Safety Recall: 26V337
May 2026

IMPORTANT SAFETY RECALL

Product Safety Notice

Models Included 2025 - 2027 Paradigm 5th Wheels.

Fig. 1

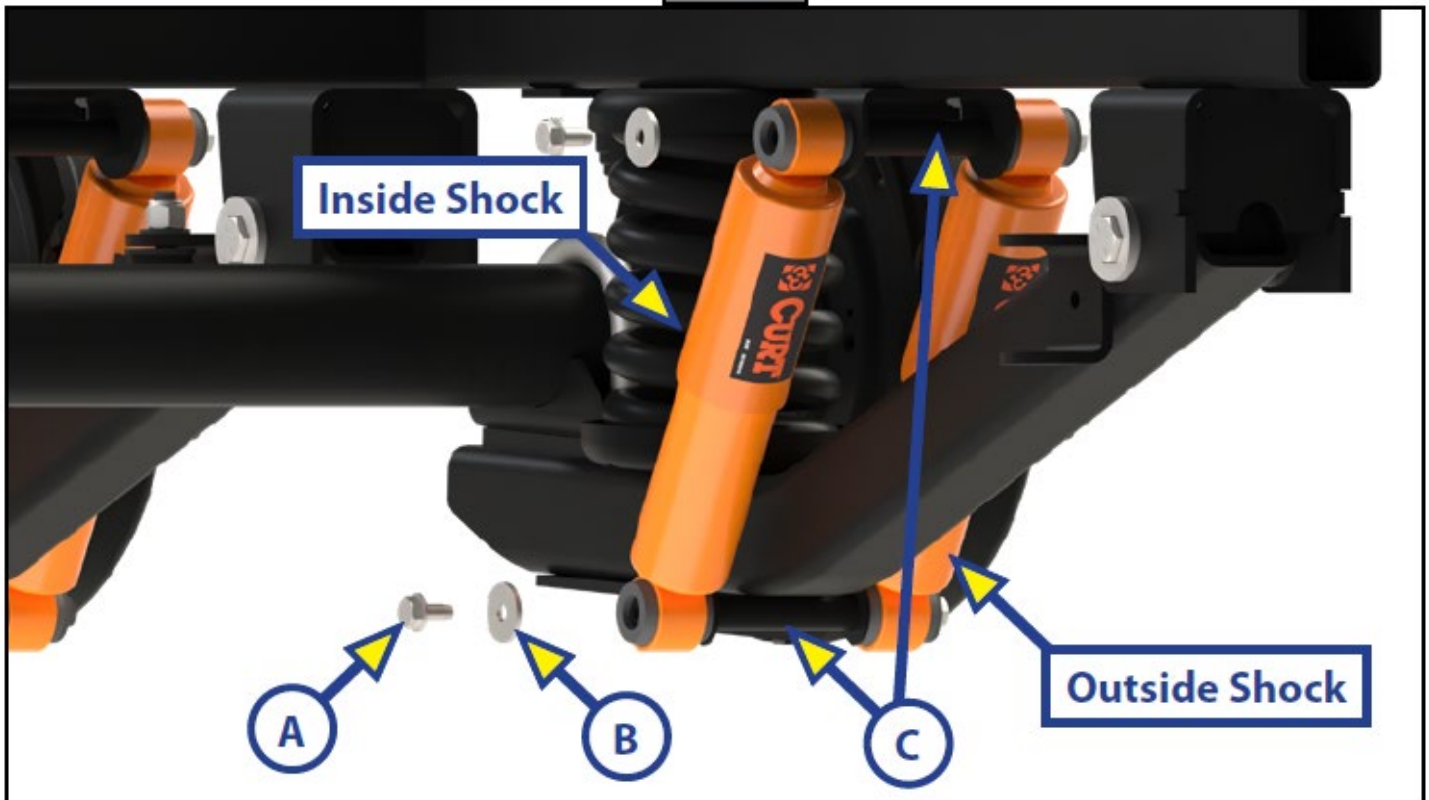
1. Starting with the inside shocks, loosen and remove the two existing 3/8"-16 x 3/4" thread forming screws (Fig. 1A) and washers (Fig. 1B) securing each shock absorber onto its posts (Fig. 1C). Retain washers (PN 249853) for reinstallation in Step 2.

2. Reinstall previously-removed washers onto two new 3/8" - 16 x 3/4" Grade 8 hex head bolts.

Fig. 2

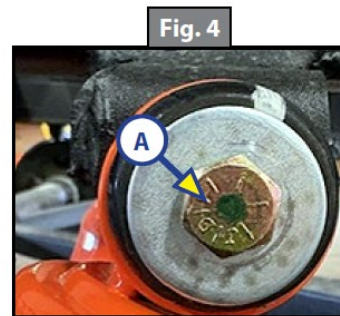
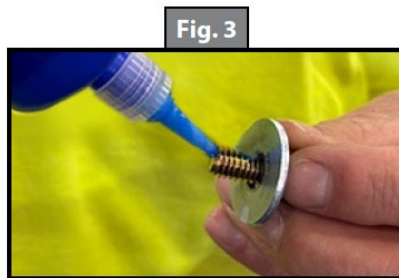
NOTE: Some kits will come with bolts pre-coated with thread locker instead of 0.02oz capsules of Loctite. If the bolts are pre-coated (Fig.2), skip step 3.

3. Apply two threads of thread locker to the Grade 8 bolt threads (Fig 2).
4. Install new bolt assemblies by hand for a minimum of three full threads (or three turns) before proceeding to step 5.
5. Torque new Grade 8 bolts to 20-30 ft-lbs. Do not over torque bolts.
6. Repeat procedure on all other inside and outside shock absorber bolts.
